1. To supplement Attachment B, please explain how SROG will monitor the pipeline between the Little Willow Facility and well DJS 2-14 to prevent leaks and/or spills.

2. *The application states on page 10 that a complete water flow testing and water analysis was done for two existing wells prior to developing the Willow Field. Data are presented for one of these two wells. To supplement Attachment E, provide the name, location, or value of Total Dissolved Solids for this other well.*

Fig 9-6 Processed log with permeability calculation (RT Scanner Log)

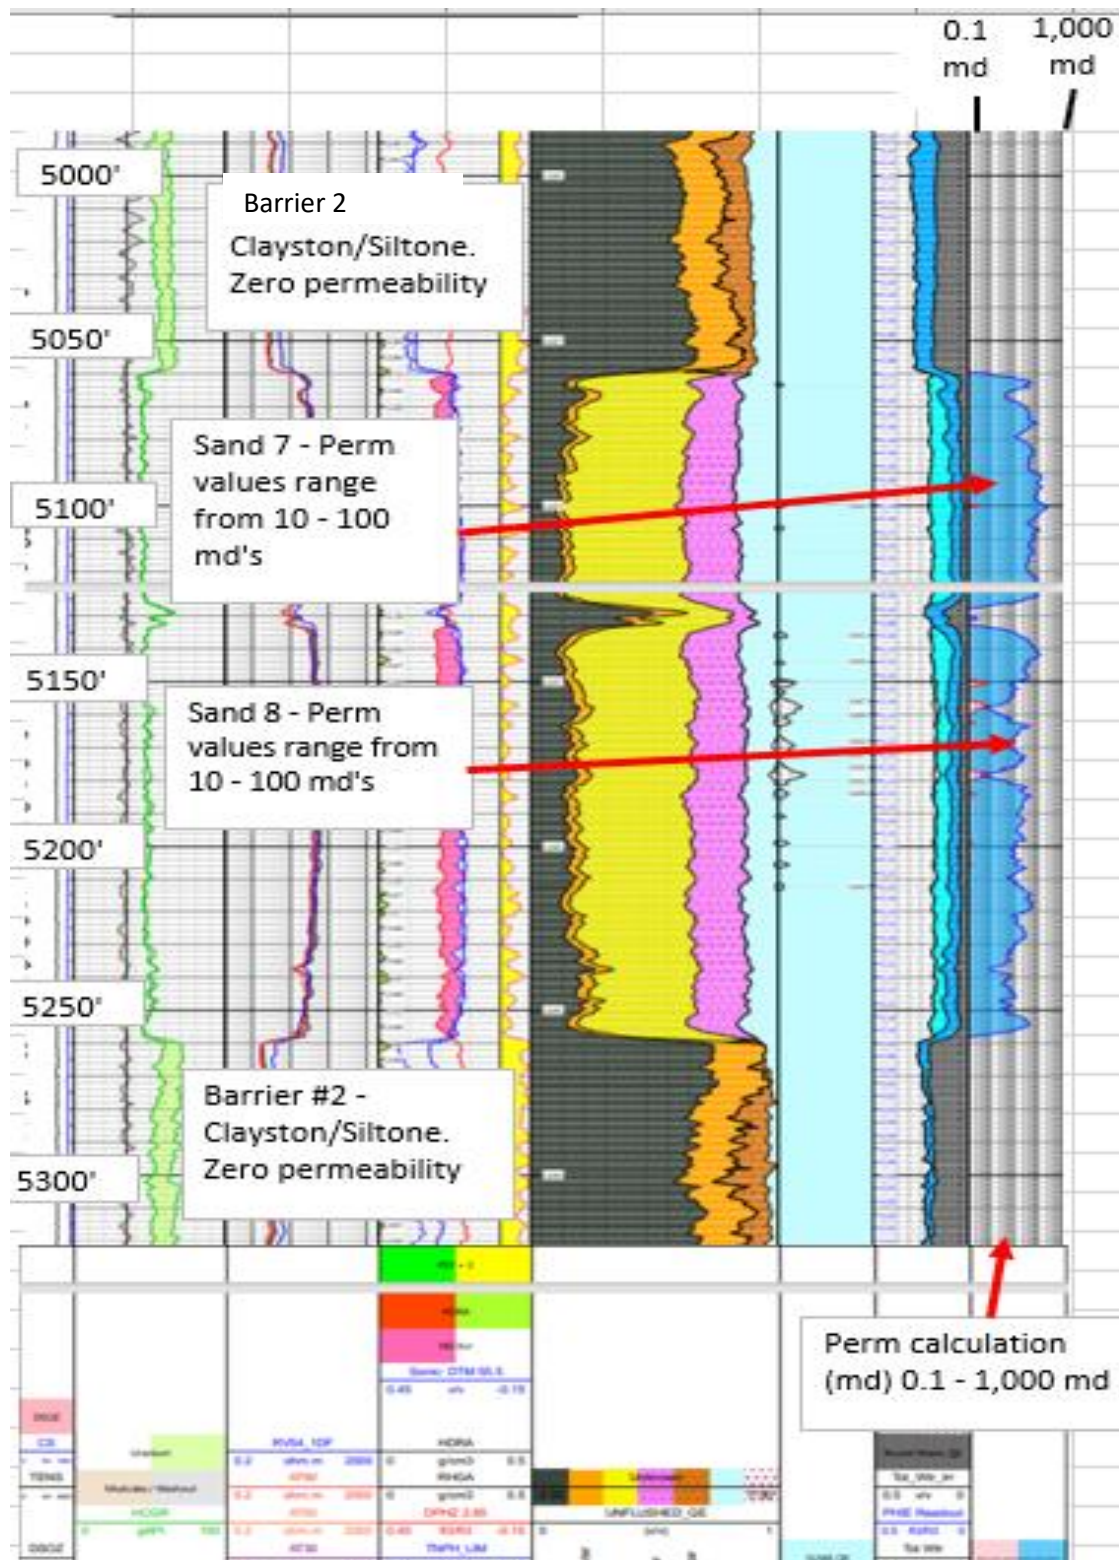
9. *To supplement Attachment G, provide evidence that the geologic intervals with volcanic character below the proposed injection zone will act as a competent lower confining interval. This may include estimates of permeability and porosity, comparisons with like-formations from other locations, or other available information.*

Similar to the upper competent seals mentioned in attachment G, the confining interval below the proposed injection zone exhibits excellent sealing characteristics as well. This argument is best supported by reviewing the well history and log data from a well drilled in 1979 by Ore-Ida Food Incorporated. This well was spudded on 8/19/79 and is located 8.6 miles west of the DJS 2-14 (see Fig 10-1). The section from 5,500' and below, is stratigraphically equivalent to the section immediately below the Willow sands in the DJS 2-14.

In addition to the unsuccessful flow test data, log data indicates the presence of a series of thick impermeable beds between 5,500' – 10,000' that exhibit a rock quality with low – zero permeability. These sections show log responses that are typical for low-zero perm rock. Evaluating the SP and resistivity curves across these log sections provide the differentiation between permeable and impermeable beds between 5,550' – 10,000'.

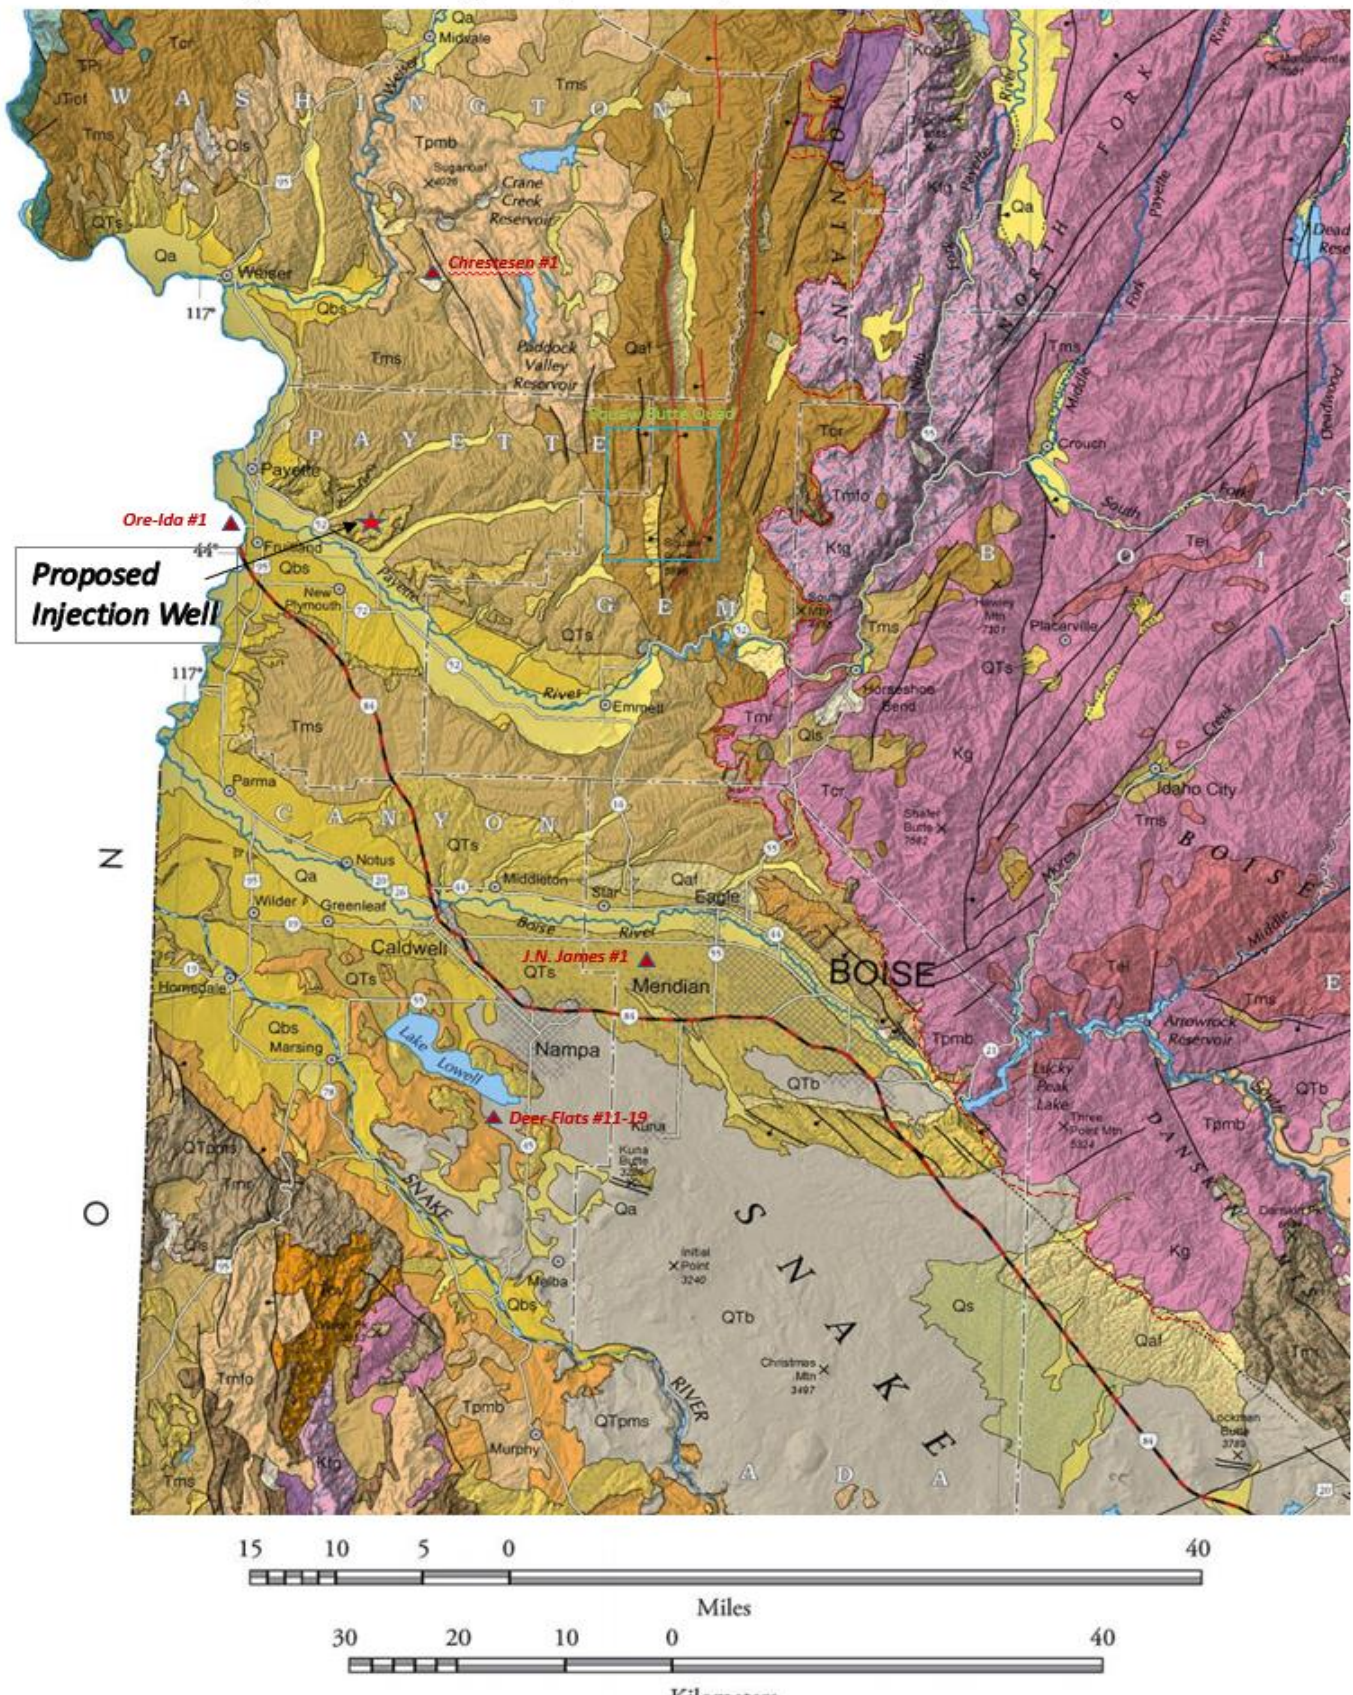
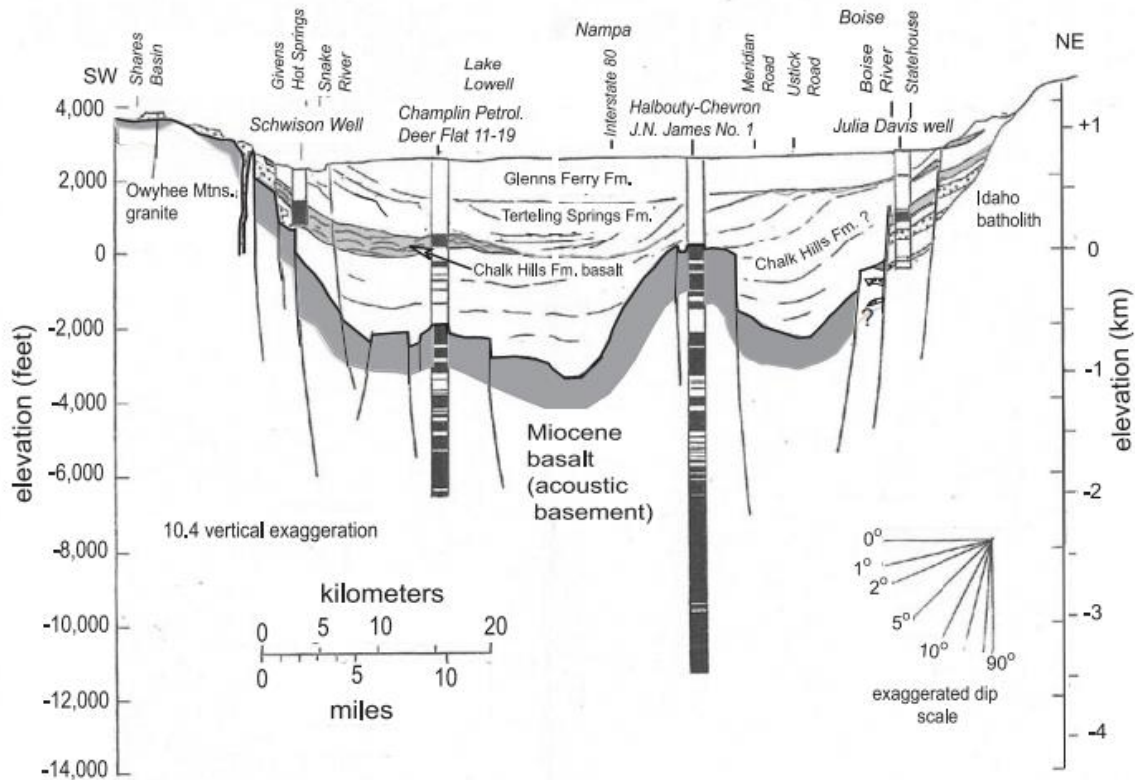
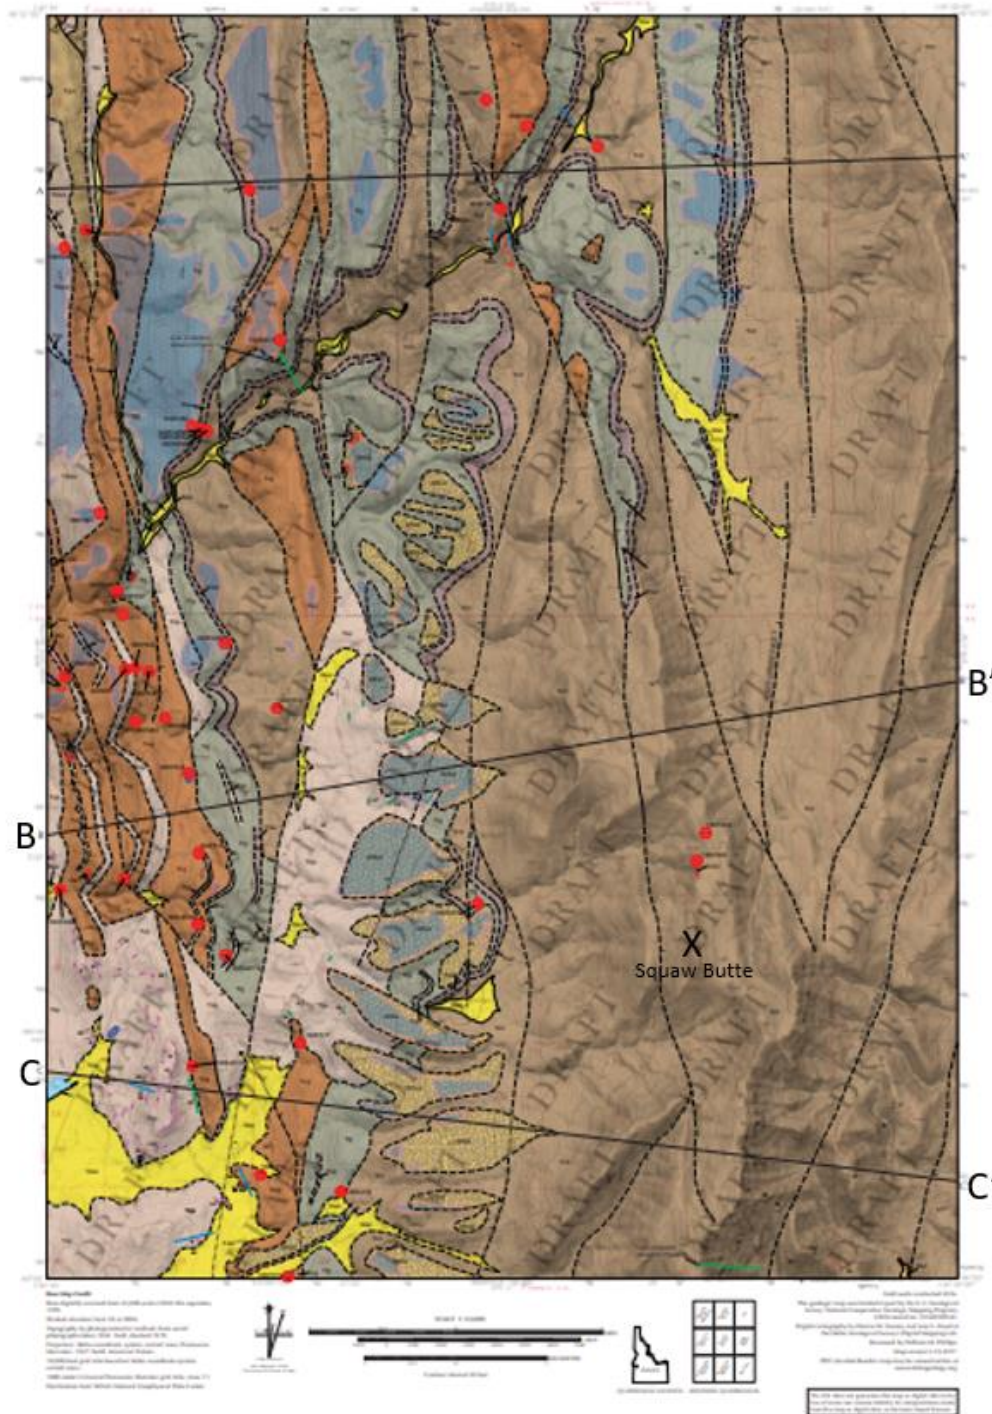
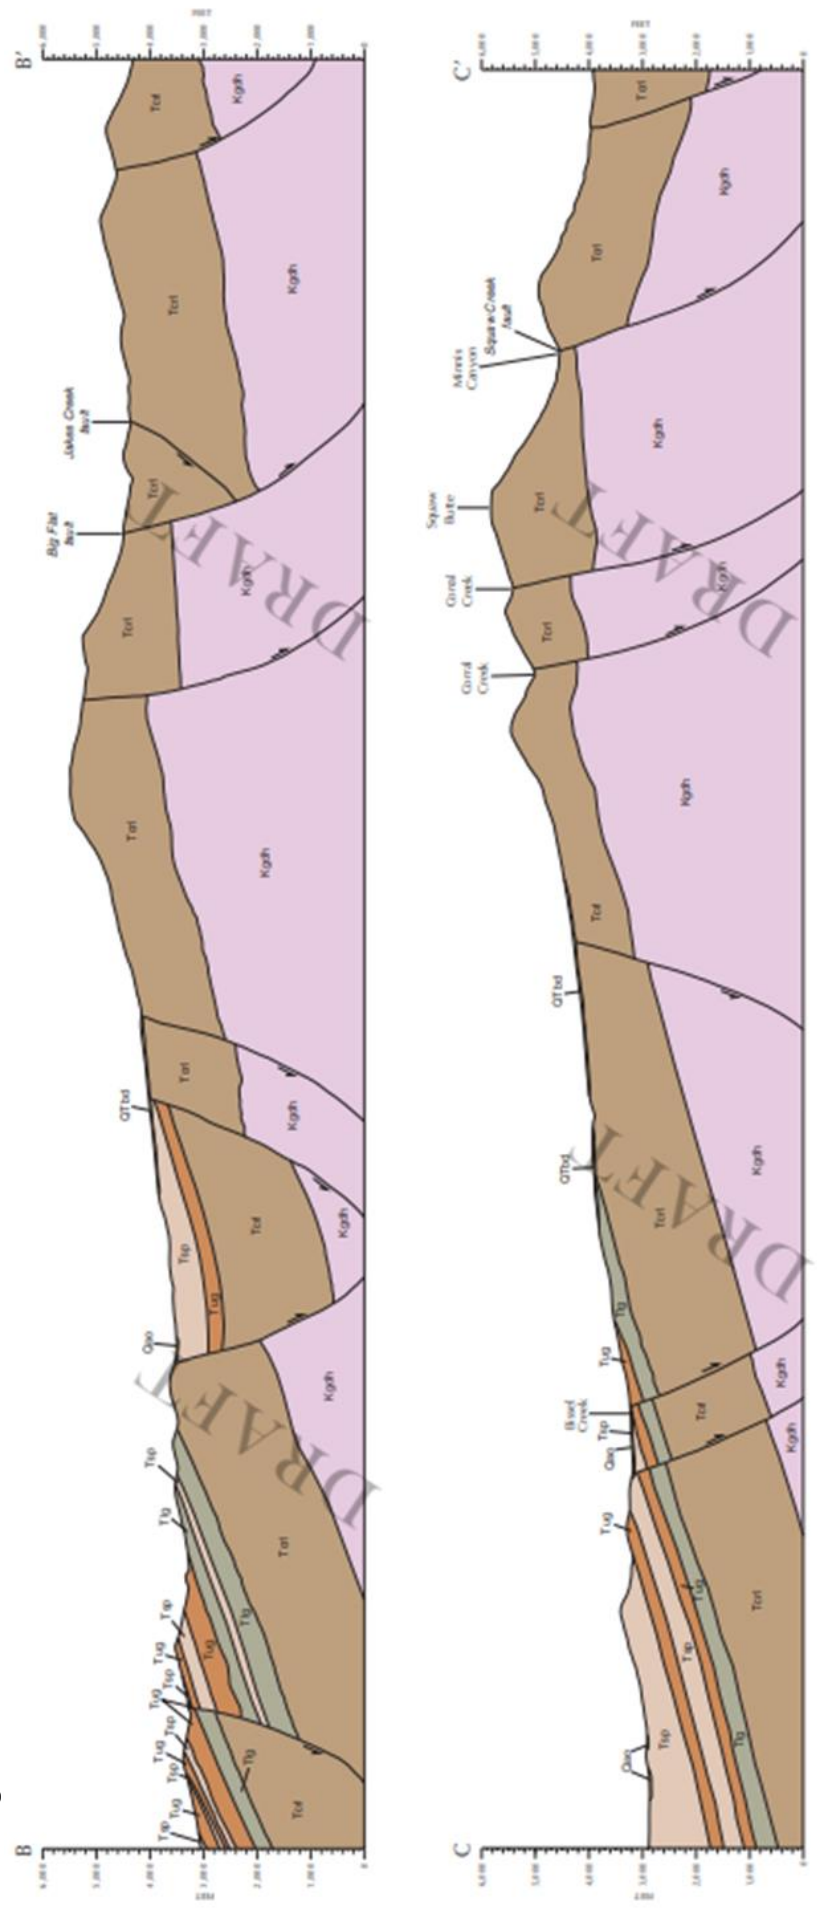
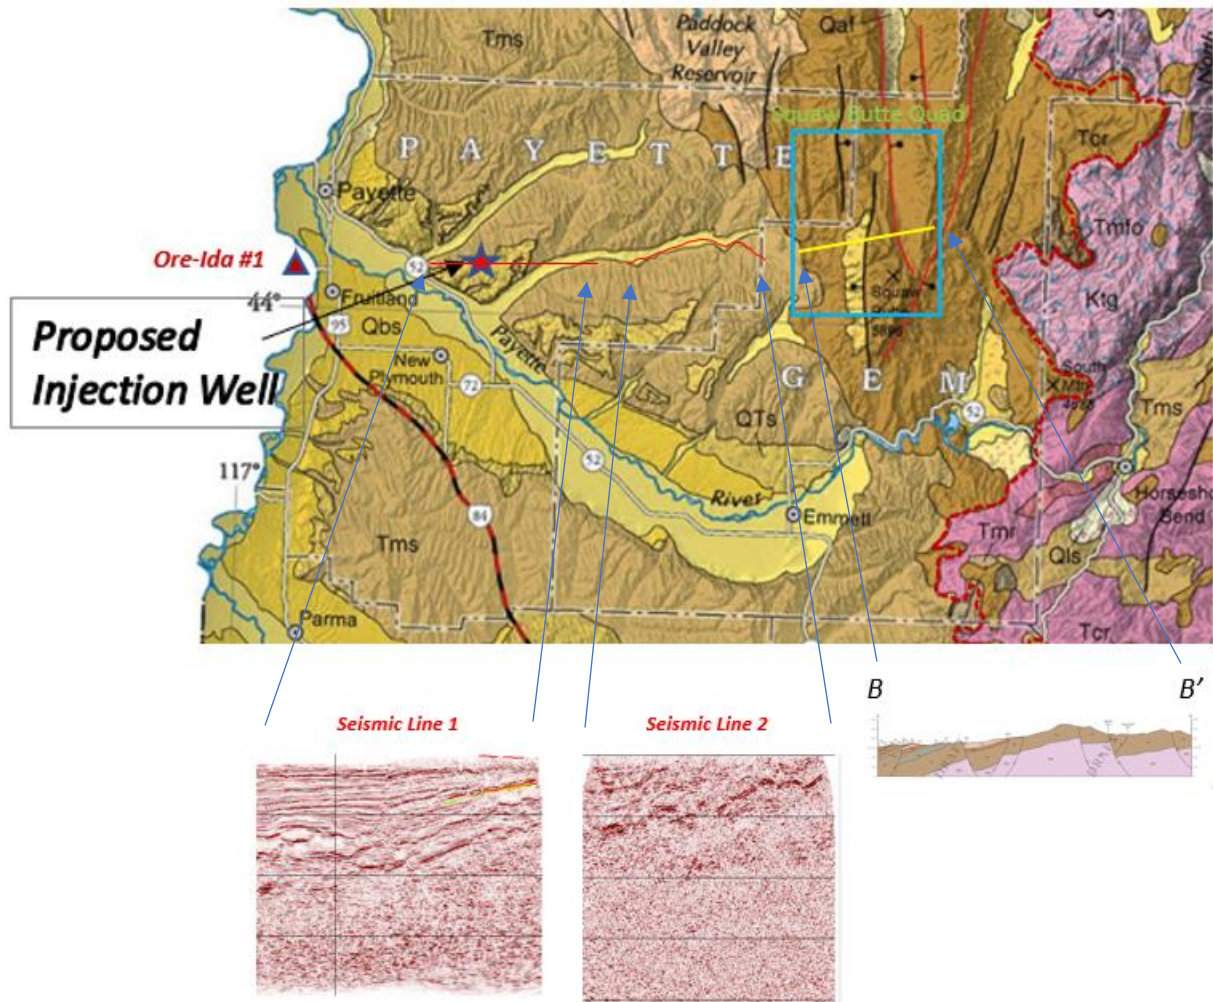
10. To supplement Attachment G, please provide a vertical distance between the injection zone and the nearest underlying instance of crystalline basement rock, if known and applicable. If not known and/or applicable, please provide the basis for SROG not obtaining this information and/or reaching this conclusion.

The Willow Sands injection zone is found from -2200' to -3700' subsea at the proposed injection well. Using simple trigonometry and projecting the Cretaceous granite surface to the injection well location estimates it to be at a depth of approximately -22,000' subsea, a vertical distance of more than 18,000' between the injection zone and crystalline basement. This method of projecting the estimated depth should not be considered exact, because of the variability of dips and additive and subtractive errors of unknown faults. Error bars of this method are likely on the order of several thousand feet.

The methods employed as discussed above to determine depth to crystalline basement each have their own inherent potential sources of error. Projecting the depth of crystalline granites into the basin with surface geologic mapping uses a tremendous number of data points collected at the surface, but the dip rates do change in the subsurface, leading to potentially large error. The deep well control can constrain the other methods, but the number of deep wells in the WSRP is few. Nonetheless, using the known thicknesses of the CRB/Sucker Ck. Sections in the Chrestesen and James wells, and projecting down from the top of the CRB in the Ore-Ida well gives a range of roughly -13,000 to -15,800'+ subsea for crystalline basement at the Ore-Ida well, which should be very similar to the depth of crystalline basement at the proposed injection well. The gravity/magnetic/refraction seismic velocity method utilizes an extremely large number of geophysical data points collected within and beyond the basin proper. The interpretation is constrained with surface geology, reflection seismic data, and the existing well control – however assumptions are made within the modelling process which can change the predicted depths to basement. Nonetheless, the methods consistently point to a predicted depth to basement at the injection well site to be between -14,000' to -20,000+' subsea. The estimated depth to crystalline basement at the proposed well site is conservatively stated to be -14,000' subsea. As the proposed injection zone is between -2200' and -3700' subsea, the vertical distance between the injection zone and the nearest underlying instance of crystalline basement rock is concluded to be over 10,000'.
